AGENDA
HISTORIC PRESERVATION BOARD
CITY HALL, CITY COMMISSION CHAMBERS
May 23, 2024, 2024 8:30 A.M.

AGENDA
DESIGN REVIEW COMMITTEE
CITY HALL, CITY COMMISSION CHAMBERS
May 23, 2024
immediately following the Historic Preservation Board Meeting

**HISTORIC PRESERVATION BOARD
DESIGN REVIEW COMMITTEE
STAFF REPORT
May 23, 2024**

Project #	HPB24-095
Project Type	Major Rehabilitation
Property Address; Historic Name	731 S. Missouri Avenue William and Ida Warren House (Lakeland City Directory 1919)
Historic District; FMSF#	Dixieland Historic District; DL 190
Owner/Applicant	Mr. Guy Afriat
Future Land Use; Zoning; Context District	Residential High; O-1; Urban Neighborhood
Existing Use	Residential
Adjacent Properties	Residential and Commercial/Office
Previous Approvals	N/A

FRONT ELEVATION
SCALE: 1/4"=1'-0"

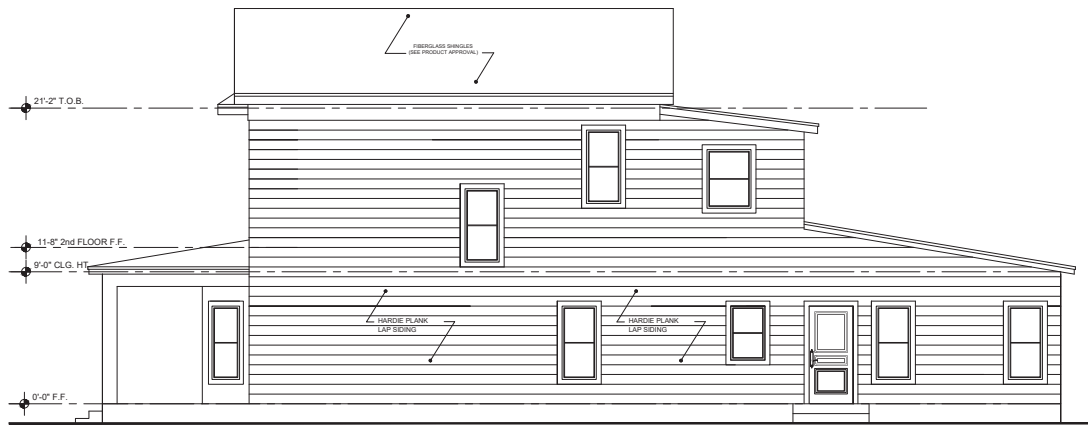
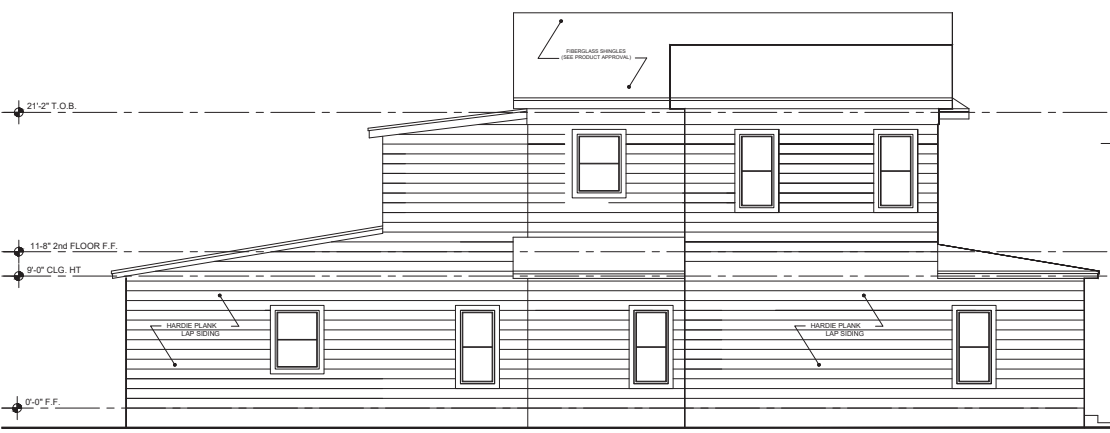
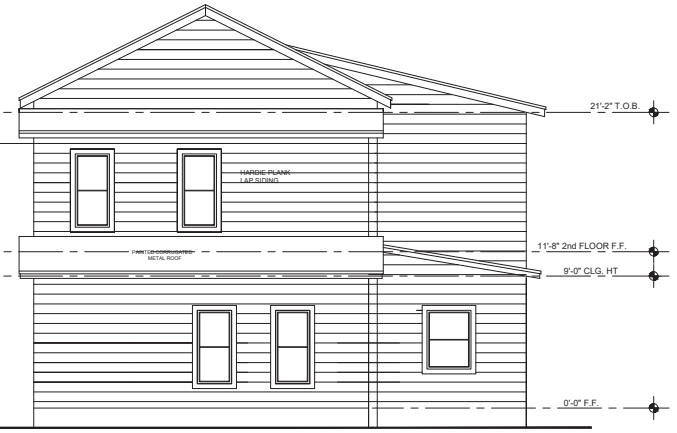
Staff finds that the request meets the Standards, as the features requested to be replaced are either not original historic fabric (asbestos shingle siding, aluminum windows, metal porch columns and handrail), or the original fabric (windows) is deteriorated beyond reasonable repair. The window and door enclosures/conversion are requested for primarily secondary elevations of the house and will not adversely affect its architectural character or integrity. The requested door enclosure on the front of the house is not a historic feature. Staff recommends preserving and repairing the central window with leaded glass on the front elevation of the house, as this is one of the few historic features remaining.

As the subject house did not originally have asbestos siding, staff finds that the use of fiber-cement lap siding for replacement siding is consistent with the Design Guidelines. Additionally, the requested window and door replacements are appropriate in size, configuration, and material. Finally, the use of simply designed wood columns and handrail is compatible with the architectural style of the house and consistent with the Design Guidelines.

1. Exterior siding must include the use of corner boards of an appropriate width at every corner of house,
2. Windows must be installed with a recess into the wall to provide a shadowline; window casing must include a traditional sill. Paired or grouped windows must have a vertical mullion of at least 4 inches wide.
3. Preserve and repair the central window with leaded glass on the front elevation, first floor.
4. Front porch columns must include a simple capital and base compatible with the Frame Vernacular architectural style of the subject house.

FRONT ELEVATION
SCALE:1/4"=1'-0"

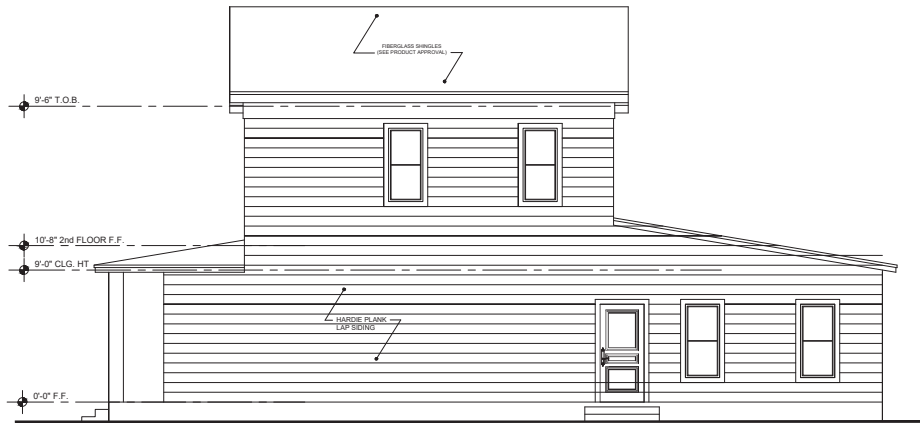
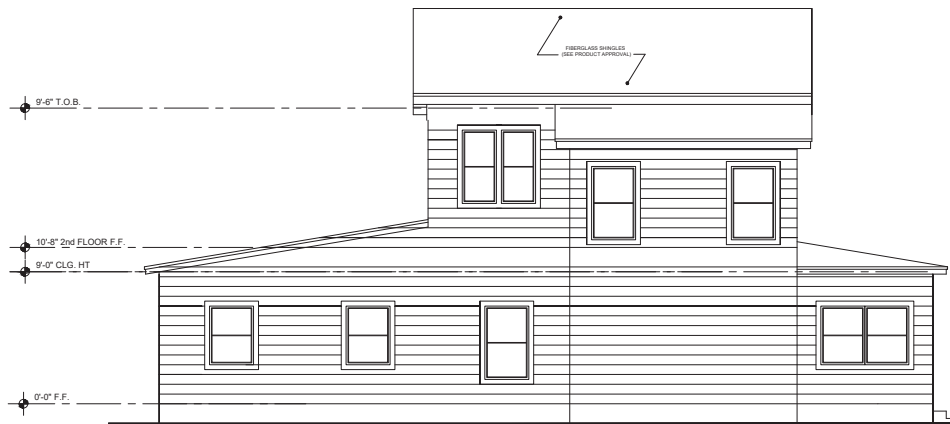
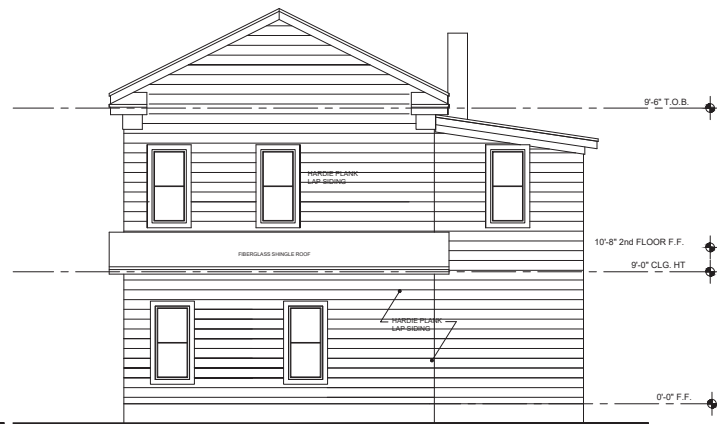
1. Remove all existing asbestos siding on the house and replace it with textured composite lap siding with a 7-inch exposure and wood grain texture.
2. Replace all existing windows with composite, single-hung sash windows matching the existing opening sizes.
3. Enclose one window opening on the north side elevation, two windows on the south side elevation, and relocate one window opening on the rear elevation. Enclosed window openings will be infilled with typical wall framing and lap siding.
4. Replace exterior doors with fiberglass three-quarter lite and half-lite doors.
5. Enclose two door openings on the front elevation of house (non-historic, used for dividing house into apartments previously) with typical wall framing and lap siding. Convert one window opening on north side elevation to a door opening.

6. Remove metal columns and handrail on front porch and replace with square wooden columns and wood handrail.

1. Exterior siding must include the use of corner boards of an appropriate width at every corner of house,
2. Windows must be installed with a recess into the wall to provide a shadowline; window casing must include a traditional sill. Paired or grouped windows must have a vertical mullion of at least 4 inches wide.
3. Front porch columns must include a simple capital and base compatible with the Frame Vernacular architectural style of the subject house.

FRONT ELEVATION
SCALE: 1/4" = 1'-0"

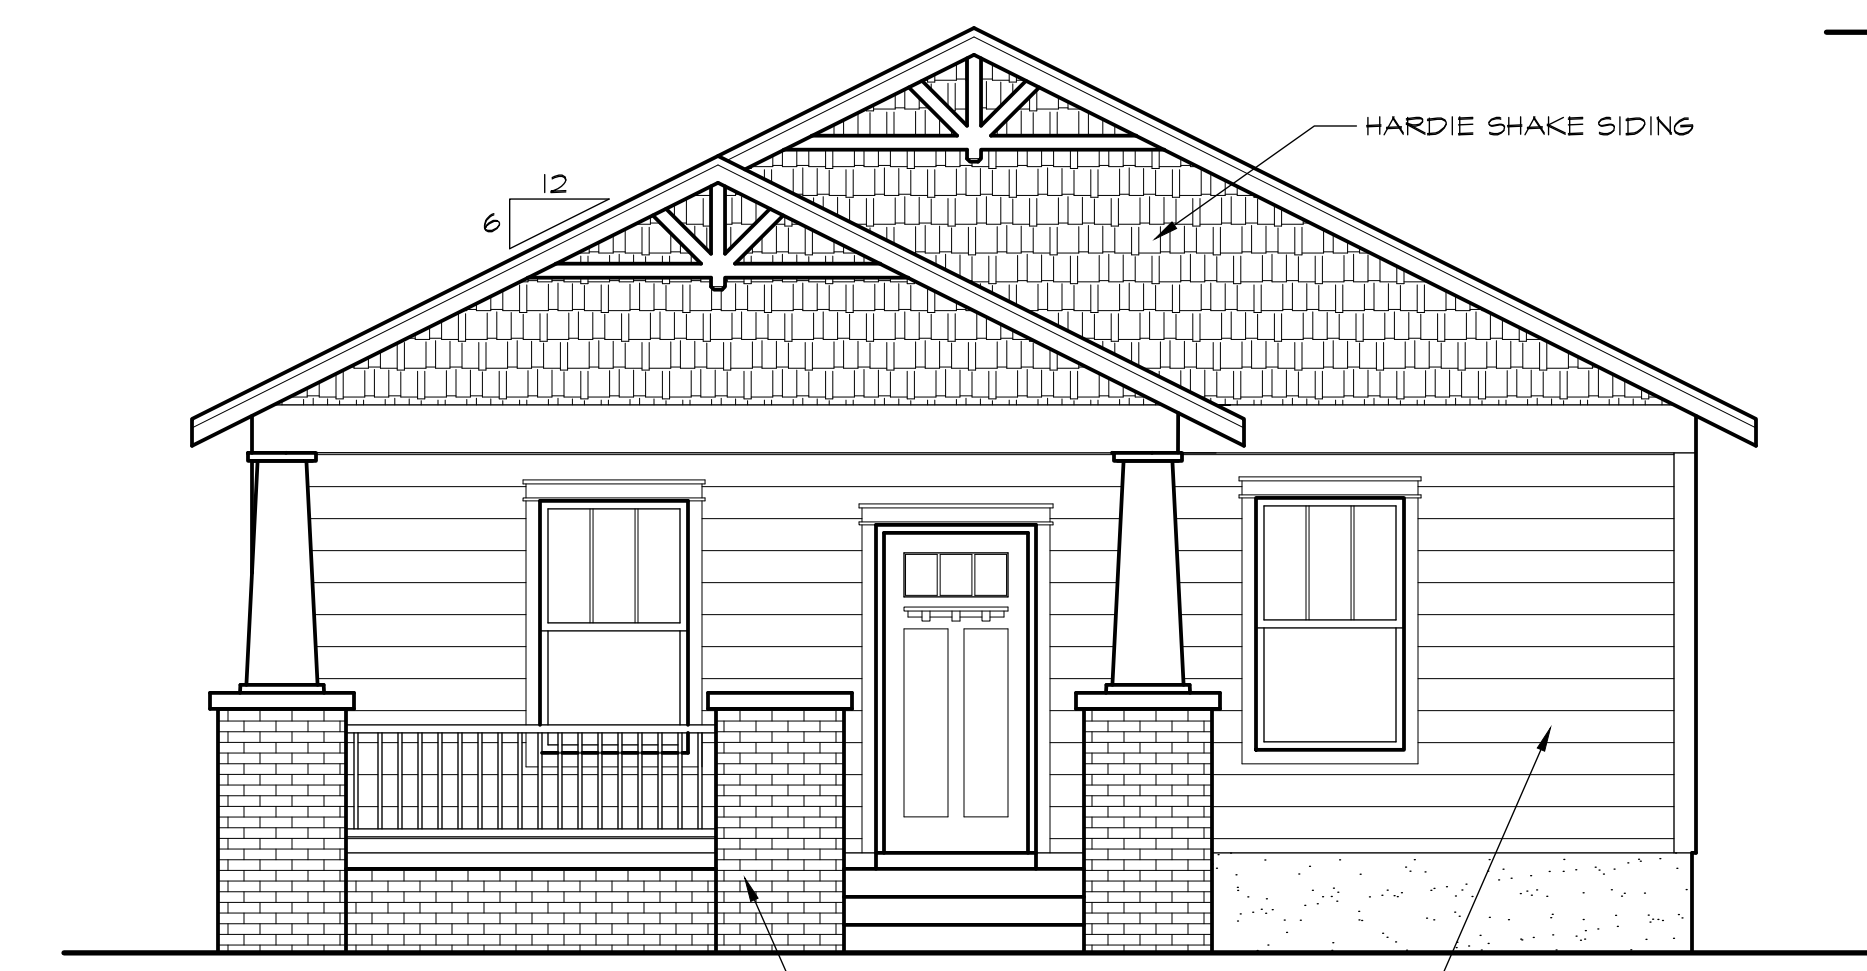
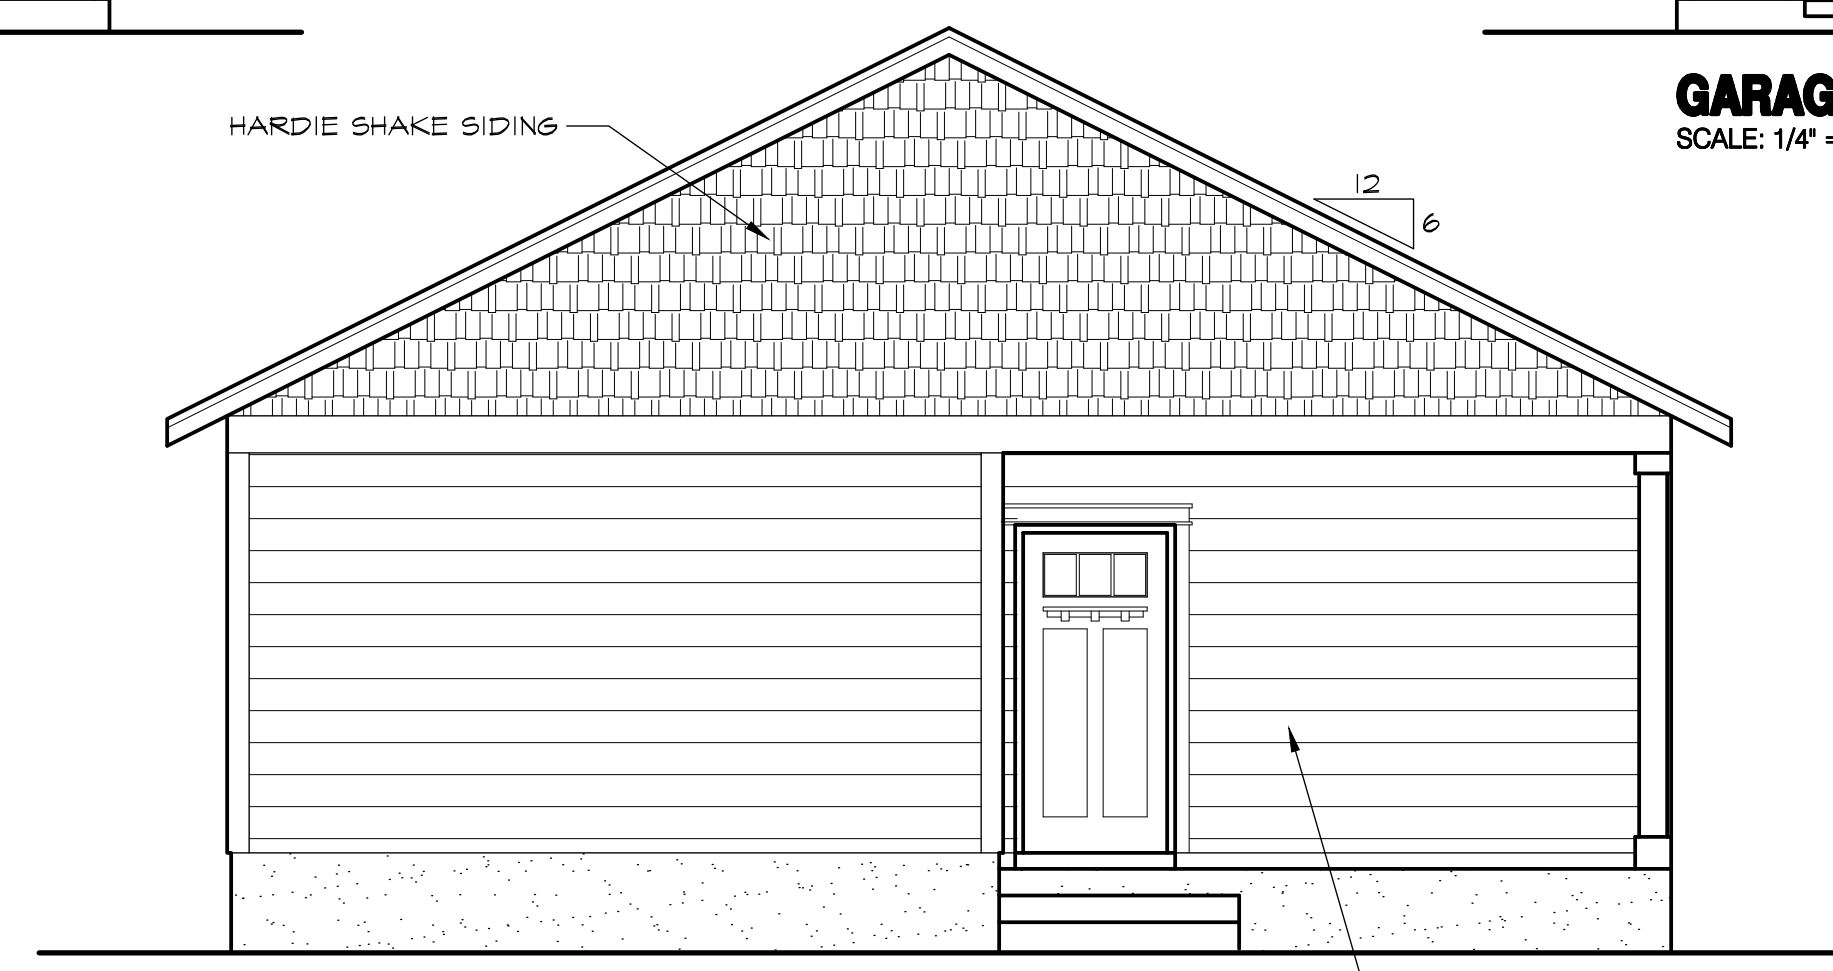
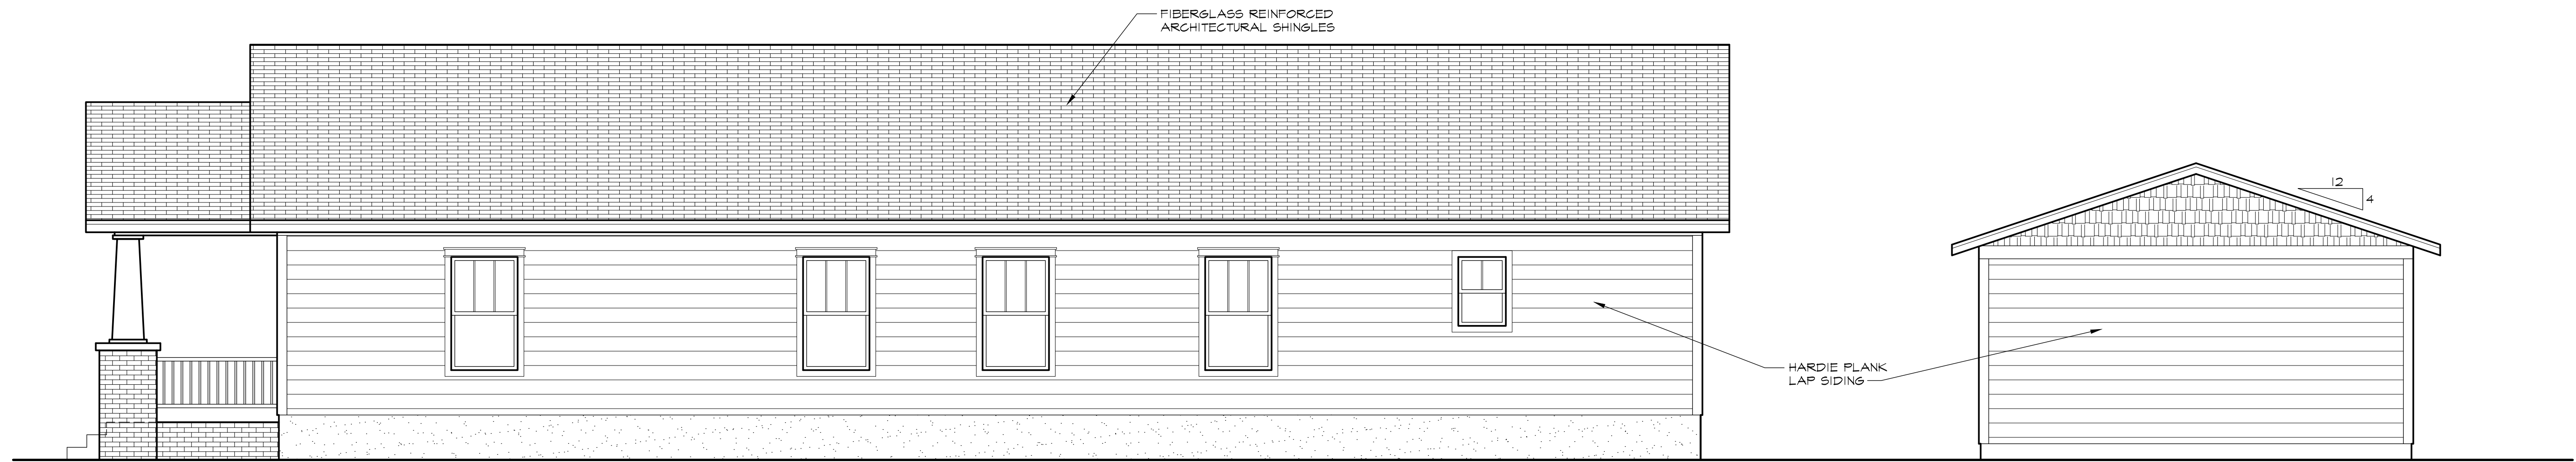
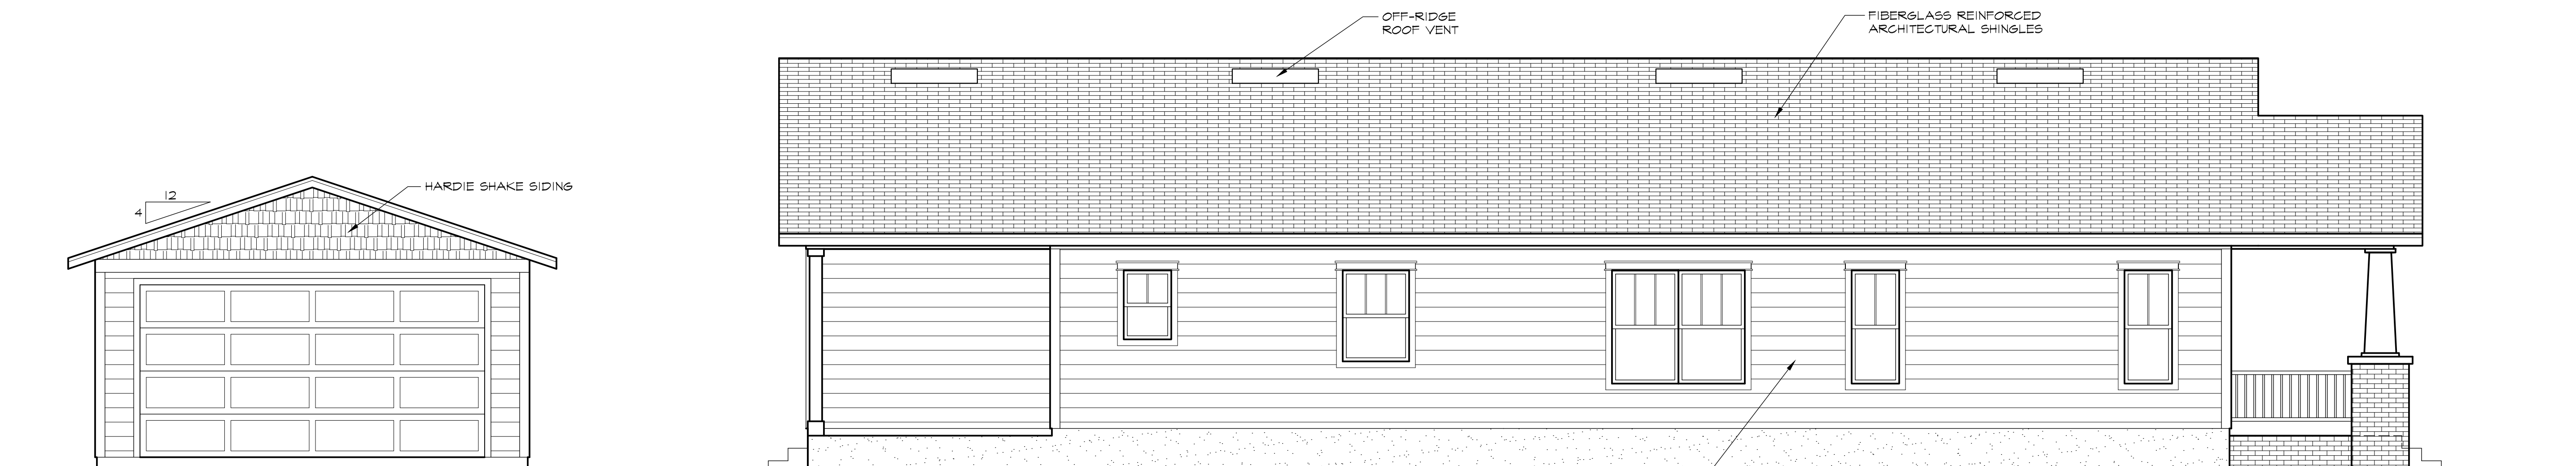
The Applicant requests to build a one-story, single-family house consisting of approximately 1,821 square feet of living area. The home will feature a neo-traditional aesthetic reflecting elements of the Craftsman Bungalow architectural style, such as a gabled roof and gabled front porch supported by tapered columns on brick plinths, windows with a three-over-one lite configuration, and a front entry consisting of a quarter-lite Craftsman style front door. The house plan features an integrated porch on the rear elevation of the house. A detached garage consisting of 400 square feet is proposed to be constructed in the rear yard, which will be accessed from the alley. Materials proposed for the new house include:

The site plan proposed for the proposed new construction shows orientation of the home's front façade towards West Hancock Street. The proposed building setbacks and porch depth for the house meet the Land Development Code's Urban Neighborhood Standards.

1. Windows must be recessed to provide a shadow line and not installed flush to the exterior wall surface. Windows also must include historically appropriate trim, including header and sill.
2. Submittal of an exterior paint palette.
